STAFF REPORT
COMMUNITY DEVELOPMENT DEPARTMENT

HEARING DATE: 5/5/2022
 TO: Planning & Zoning Commission
 FROM: Joseph Dodson, Associate Planner
 208-884-5533
 SUBJECT: H-2021-0103
 Ferney Subdivision

Annexation and Zoning of 5.64 acres with a request for the I-L zoning district and a Preliminary Plat consisting of two (2) building lots on 4.93 acres of land in the requested I-L zoning district.

EXHIBIT MAP

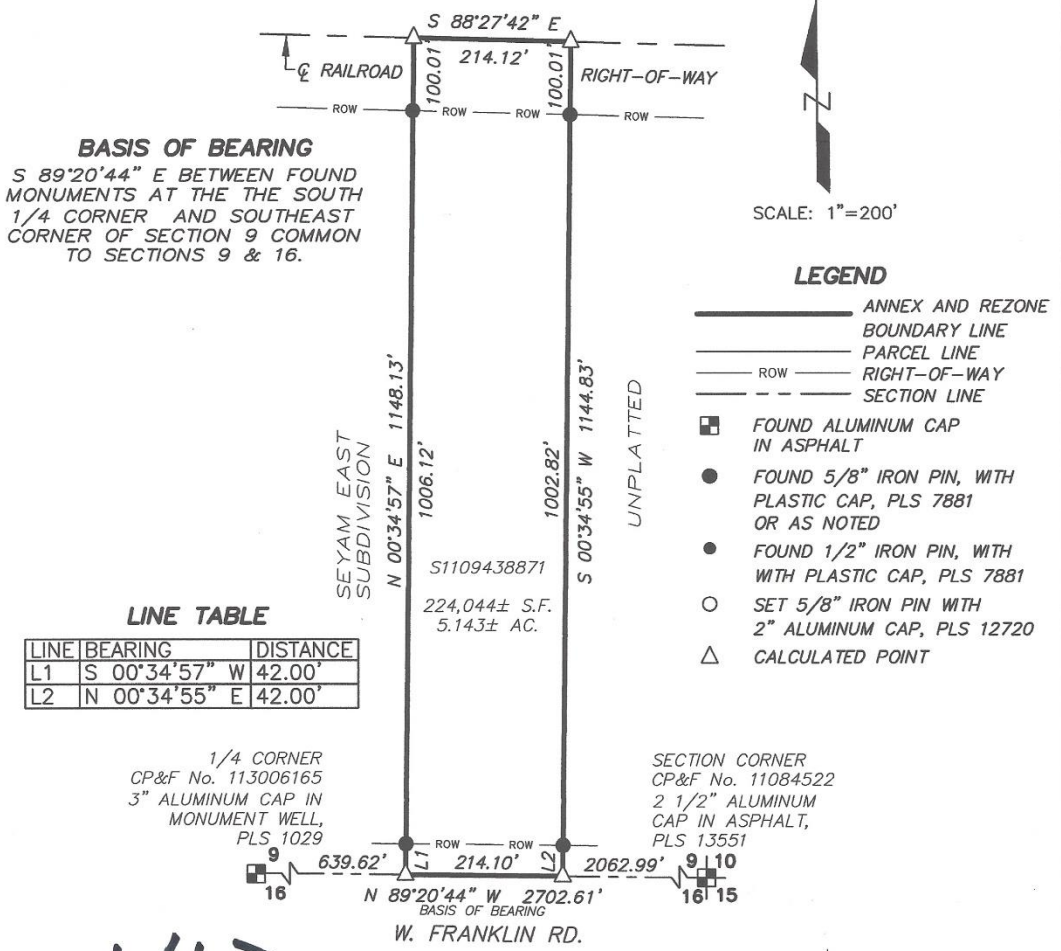
With previous applications north of the subject site, Applicants did not annex to the centerline of the railroad right-of-way which was a mistake and the City did not catch it. In light of this, Staff is asking the Applicant to revise their annexation and zoning request to include the full railroad right-of-way instead of just to the centerline. Staff has included this comment within the conditions of approval.

Please submit a revised annexation legal description and exhibit map 15 days prior to the City Council hearing that includes the full width of the railroad right-of-way north of the subject site.

LANDSCAPE PLAN

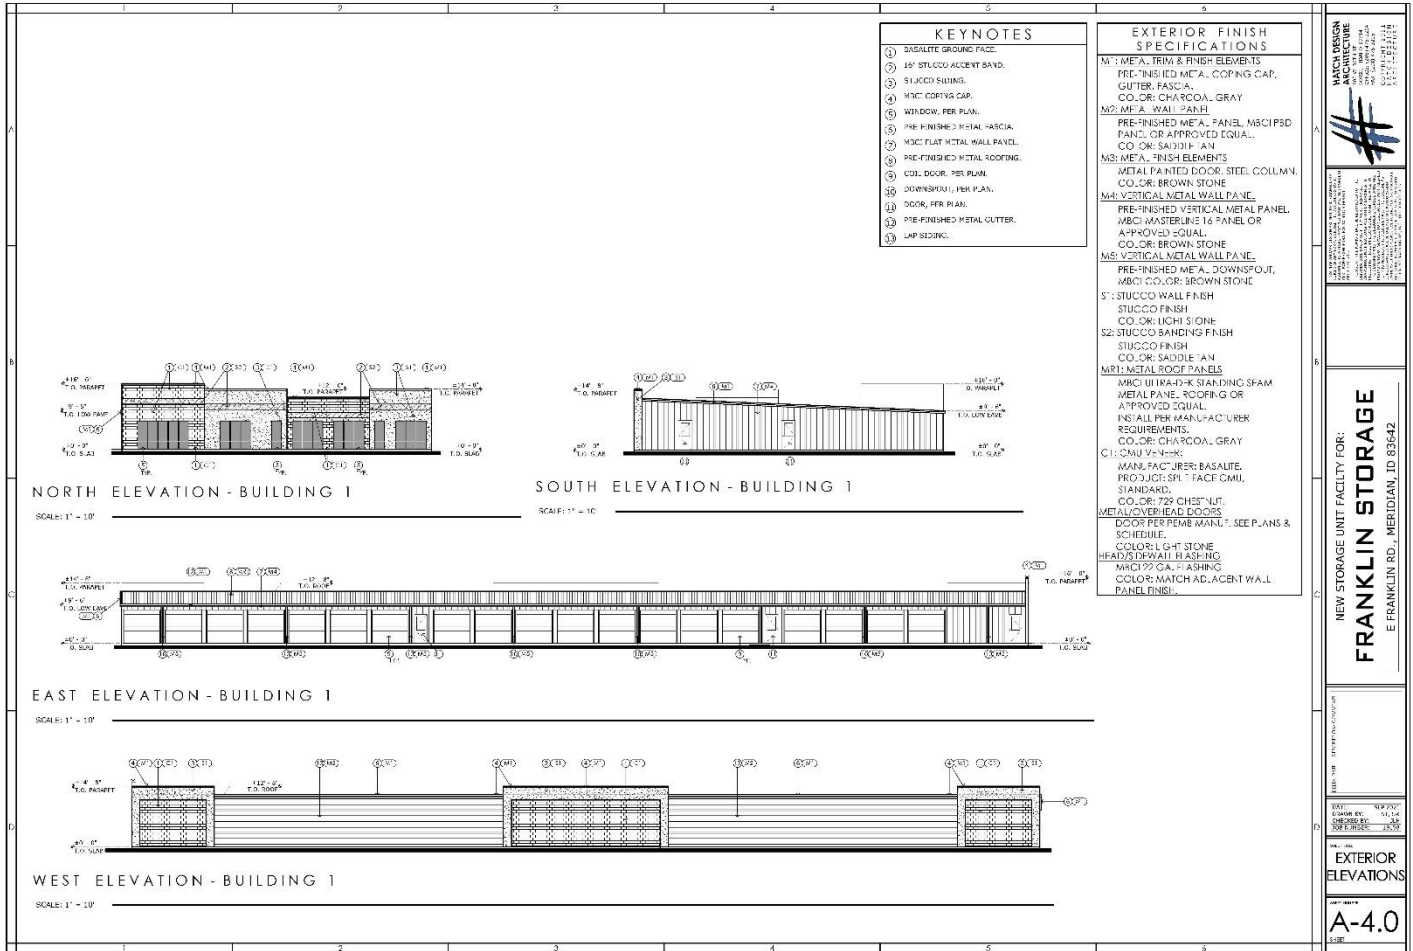
A 20-foot wide landscape buffer is required on both sides of the E. Lanark Street extension, an industrial collector street—the submitted plat depicts at least a 20 feet wide easement on both sides of this road extension measured from approximately the middle of the detached sidewalk. Therefore, the parkway strips between the sidewalks and back of curb for Lanark are not shown as part of the landscape easement.

Staff has concerns with the parkways strips not being included within the landscape buffer easements along Lanark and the lack of any vegetation shown within these parkways on the submitted landscape plans. Staff recommends the landscape buffer easement be extended to the back of curb to comply with the UDC and to revise the landscape plans to show additional grasses within the parkway strip. Further, the landscape buffers along Lanark do not show the required vegetative ground cover, similar to the Franklin buffer. Therefore, Staff is also including

No fencing is shown on the submitted landscape plan but fencing is required per the specific use standards for the proposed self-service storage facility use adjacent to the existing residential use to the east. Staff is including a condition of approval to include code compliant fencing along the entire east property boundary.

Because this area of the plat is adjacent to a vehicular use area around the Flex building, parking lot landscaping is required per UDC 11-3B-8 and should include trees and other vegetative ground cover. The submitted landscape plans do not depict any trees within this area as the irrigation easement does not allow trees. Further, the Applicant will need to obtain a license agreement with the irrigation district in order to construct what is shown on the landscape plans. Staff does not find what is proposed on the landscape plans to comply with the minimum code requirements discussed. The Applicant should submit for Alternative Compliance with the future final plat to propose an equal or superior means of complying the landscaping outlined in UDC 11-3B-8 within or adjacent to the Evans Drain easement.

2. The preliminary plat included in Section VII.B, dated December 21, 2021, shall be revised as follows at least fifteen (15) days prior to the City Council hearing:
 - a. Show the required landscape easements adjacent to E. Lanark Street to include the parkways along Lanark and start at the back of curb.
3. The landscape plan included in Section VII.D, stamped on March 16, 2022, shall be revised as follows at least fifteen (15) days prior to the City Council hearing:
 - a. Per UDC 11-3B-7C.3, depict no more than 65% of the landscape buffer area to be comprised of grasses for all required landscape street buffers (adjacent to Franklin and Lanark).

- b. Per UDC 11-3B-7C.3 for development along entryway corridors, depict additional landscape features within the 35-foot buffer along E. Franklin Road.

- c. Include additional trees and show they will touch at maturity along the east property boundary for a minimum of the first 185 feet measured from the back of the existing sidewalk for additional screening.

- d. Depict the proposed type of fencing on a sheet within the landscape plans to ensure compliance with UDC 11-3A-7 and the applicable specific use standards. Chainlink fencing with or without slats does not qualify as a screening material in accord with UDC 11-3B-5M.

D. Conceptual Building Elevations (full file linked [here](#))

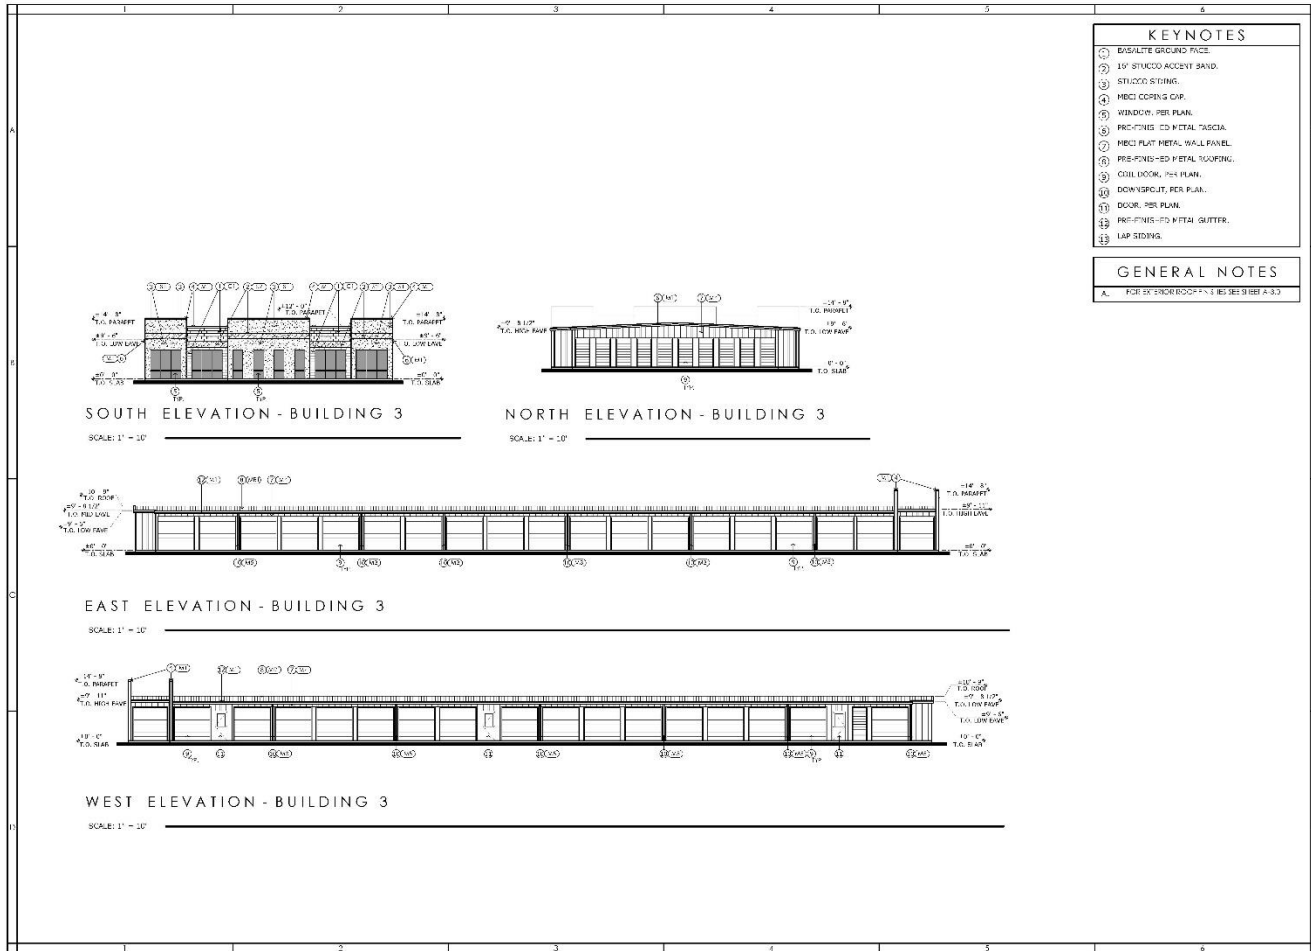
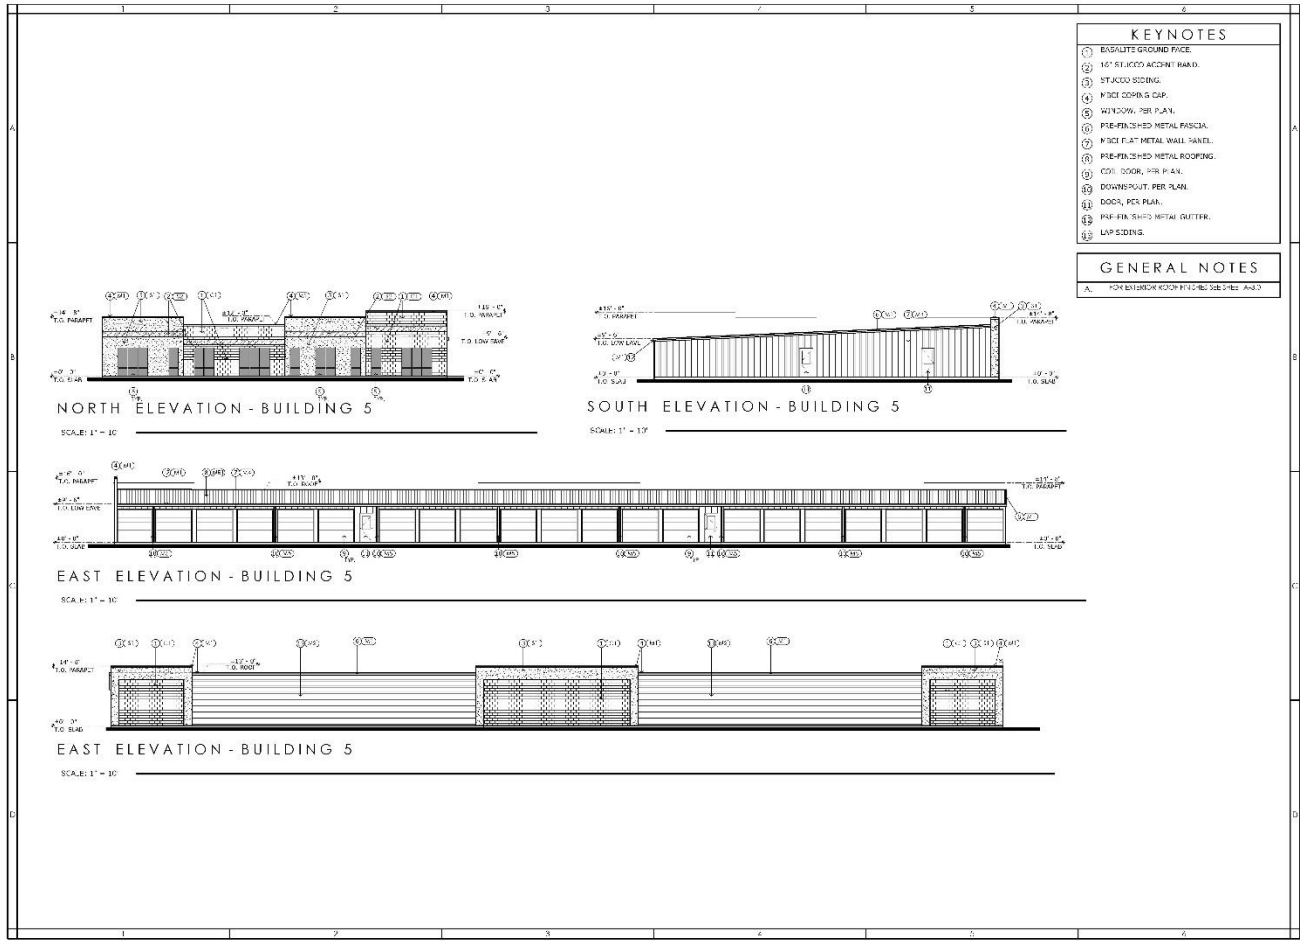
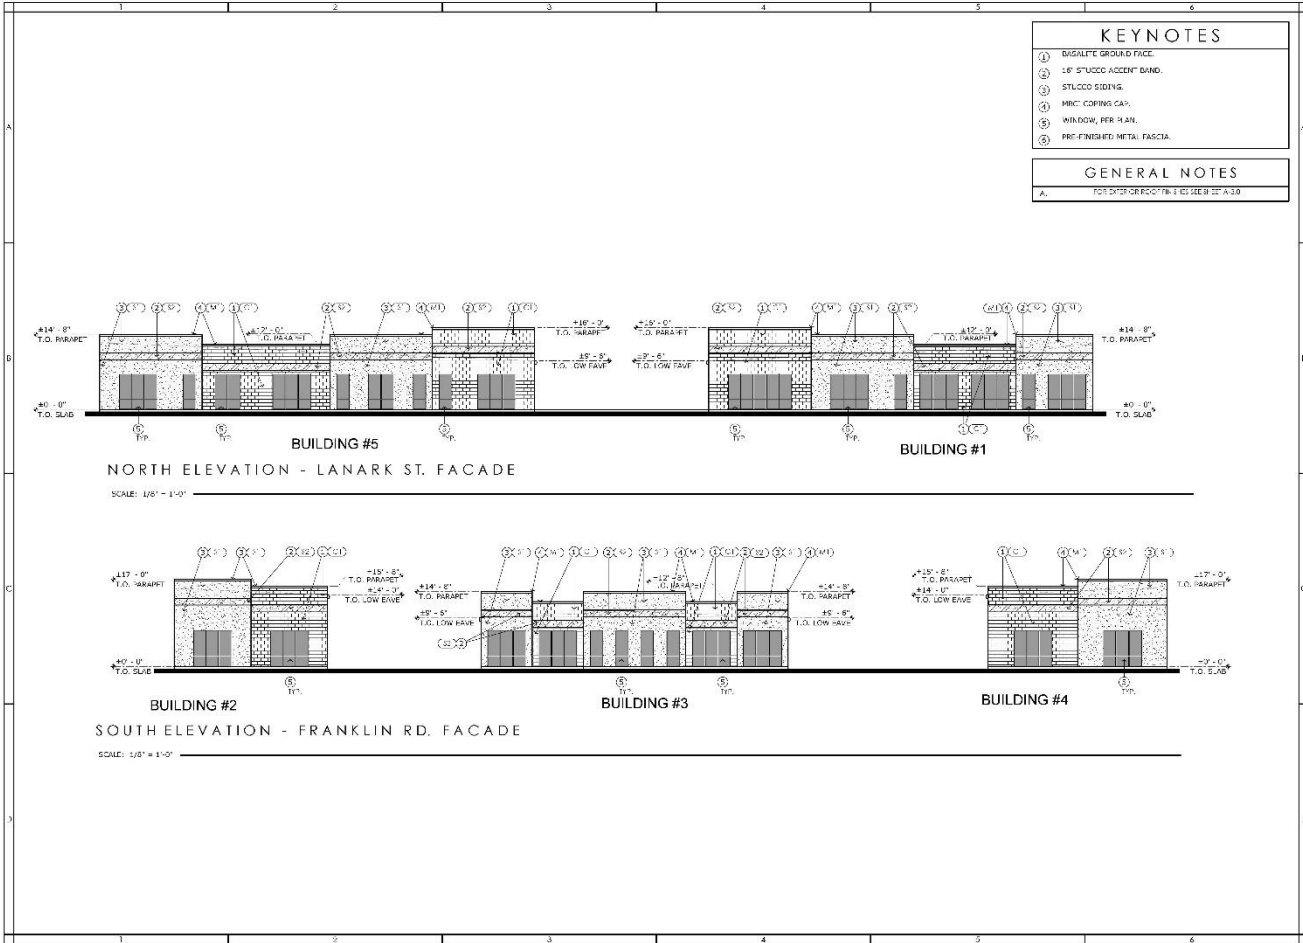
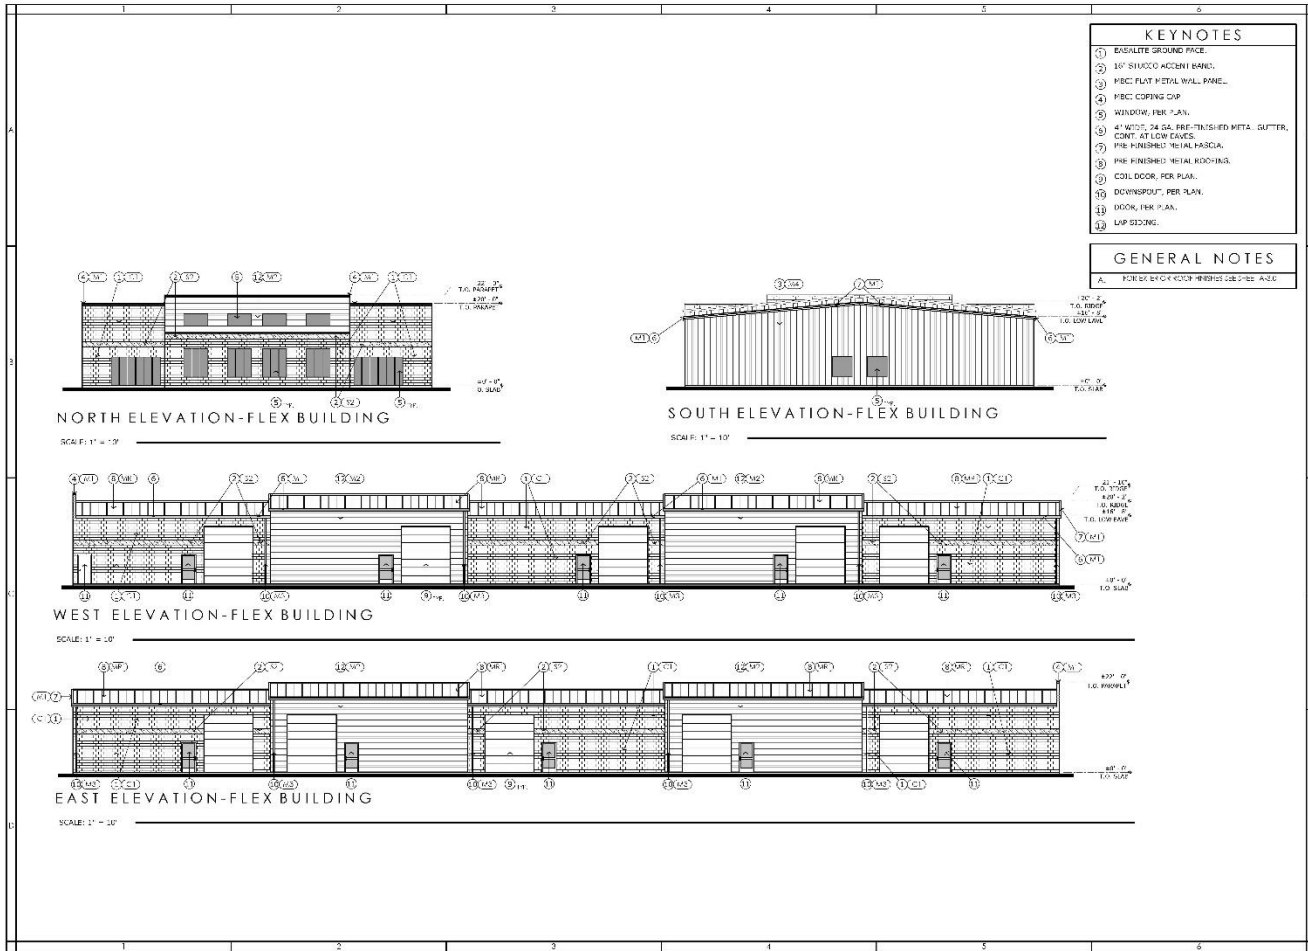
The conceptual elevations submitted depict 17-foot tall storage buildings at their highest and a 21-foot tall flex building. The storage buildings vary in overall size but appear to show varying roof profiles and finish materials facing relevant areas (roadways and the residence to the east). However, it is not entirely clear if the paneling shown facing the residence is metal or otherwise; metal paneling will not be allowed as a future field material. Overall, Staff finds the conceptual elevations should comply with the relevant standards but will review it in more detail at the time of CZC and Design Review submittal.

- f. The Applicant shall comply with the Commercial architectural design standards in the City of Meridian's Architectural Standards Manual (ASM) at the time of Certificate of Zoning Compliance and Design Review submittal for the elevations facing Franklin and the east elevations of the two storage buildings adjacent to the existing residence on Parcel S1109438907.
